Hornsea Project Three
Offshore Wind Farm

Applicant's Comments on Relevant Representations
submitted to Deadline I

Date: 7th November 2018

Figure 1.2.30.1 Vessel routes to and from Great Yarmouth

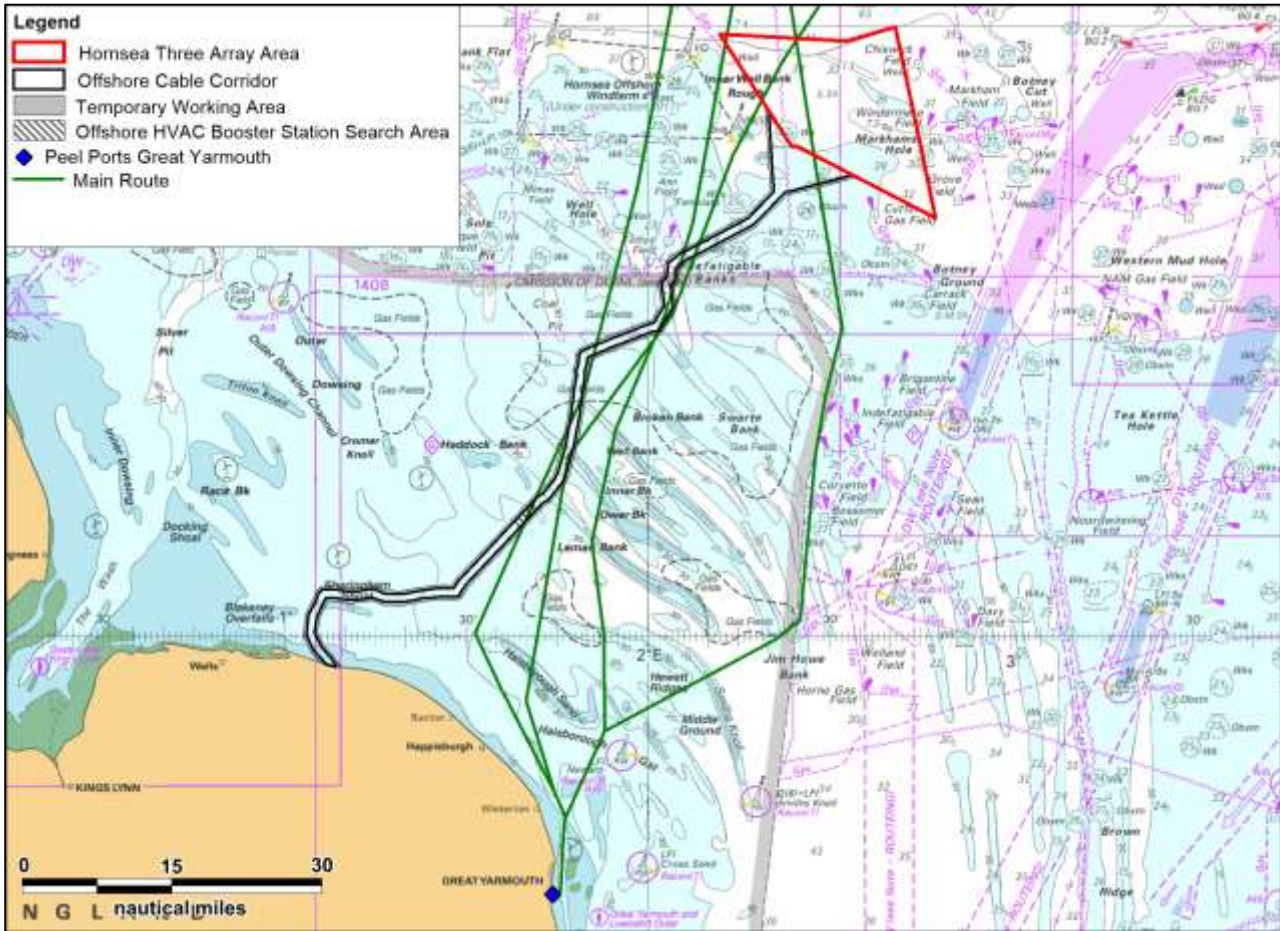
Relevant Representation Comment	Applicant's Response
<p>I refer to our letter of 20th September 2017. GYPC would like to emphasise that our interest are Port related and the potential effects on our operational interests and the statutory interests of the Port Authority which include navigational safety, shipping movements and dredging activities. As an interested party we are seeking the necessary assurance that vessel access to the Port will in no way be affected, construction and operation of the windfarm will not impact on port's radar, navigational or communications systems or that the construction or operations will not impede or otherwise adversely affect the dredging regime, infrastructure or operation of the Port.</p>	<p>The Applicant thanks Peel Ports for their response to the Hornsea Three application and their previous response to the Hornsea Three Preliminary Environmental Information Report (PEIR).</p> <p>As part of the Environmental Impact Assessment, an assessment was undertaken on potential impacts on shipping and navigation receptors in line with the Maritime and Coastguard Agency (MCA) Marine Guidance Note (MGN) 543, which requires specific consideration of (but not limited to) areas used for anchorage, safe haven, port approaches and pilot boarding or landing areas. This assessment was undertaken initially as part of the Navigational Risk Assessment (NRA) before then being assessed as part of the Environmental Statement. The NRA process included consultation with key stakeholders during which a hazard workshop was held, to which a Peel Ports representative was invited (see Hornsea Three Environmental Statement, Section 20 of Volume 5, Annex 7.1: Navigational Risk Assessment) [APP-112].</p> <p>The Navigational Risk Assessment (Volume 5, Annex 7.1 of the Environmental Statement) [APP-112] considers ports, particularly noting that the closest port to the Hornsea Three Array Area is Great Yarmouth, but that this port is located 76 nautical miles away to the south west of the array area. The proposed export cable corridor is also located to the north of Great Yarmouth with a landfall at Weybourne on the North Norfolk coast. Given the distance between the array area, the export cable corridor and the port of Great Yarmouth, there are not considered to be any direct or indirect impacts. Outputs of the assessment can be found in Section 22.8 of Volume 5, Annex 7.1: Navigational Risk Assessment of the ES [APP-112].</p> <p>The NRA also considered routing and did identify regular vessel routes to and from Great Yarmouth which intersected the proposed Hornsea Three Array Area – as shown in the Figure 1.2.30.1 below this table. The identified routes consist of Oil & Gas support vessels transiting up to one vessel per two days to gas fields such as Murdoch, Schooner and Ketch. Regarding direct impacts to Peel Ports' activities; due to the distance and the available sea room, the assessment concluded that there were no significant impacts on those routes or any impact on potential future increases to vessel numbers. Please see Section 17 of Volume 5, Annex 7.1: Navigational Risk Assessment of the ES [APP-112] for more detailed information.</p>

Relevant Representation Comment	Applicant's Response
	<p>Routes will also cross the export cable corridor, and Hornsea Three is committed to undertaking a cable burial assessment post consent (in line with MGN 543) to ensure that navigable depths are not adversely impacted (Section 23 of Volume 5, Annex 7.1: Navigational Risk Assessment) [APP-112]. Given the water depths that the cable corridor is to be installed in, the short duration of the installation of the cable and the distance from any notable commercial ports, impacts were assessed to be within acceptable limits.</p> <p>Given the early stage in the development process it is not yet possible to identify which ports will be used for construction, operation or maintenance of the Hornsea Three Array or Export Cable Corridor. However, measures adopted as part of the Hornsea Three application include Marine Coordination that will ensure that project vessels do not present an unacceptable risk to each other or to transiting vessels; therefore there are not anticipated to be any effects on existing vessel operations being undertaken within or near the ports that are finally selected.</p> <p>Other measures adopted as part of Hornsea Three will aid the safe management of shipping and navigation within the Hornsea Three Array Area, Export Cable Corridor and during the overarching construction process. The full list is contained within Section 23 of Volume 5, Annex 7.1: Navigational Risk Assessment of the Environmental Statement [APP-112]. However, a few notable examples are listed below which should give reassurance that operations and activities at the Port of Great Yarmouth will not be adversely impacted:</p> <ul style="list-style-type: none"> • Compliance with UK and Flag State regulations and IMO conventions including COLREGs and SOLAS; • Regarding vessel health and safety requirements, Hornsea Three will ensure that all project related vessels meet both IMO conventions for safe operation as well as HSE requirements, where applicable; • Promulgation of information; • Compliance with MGN 543; and • Cable burial assessment and periodic surveys.
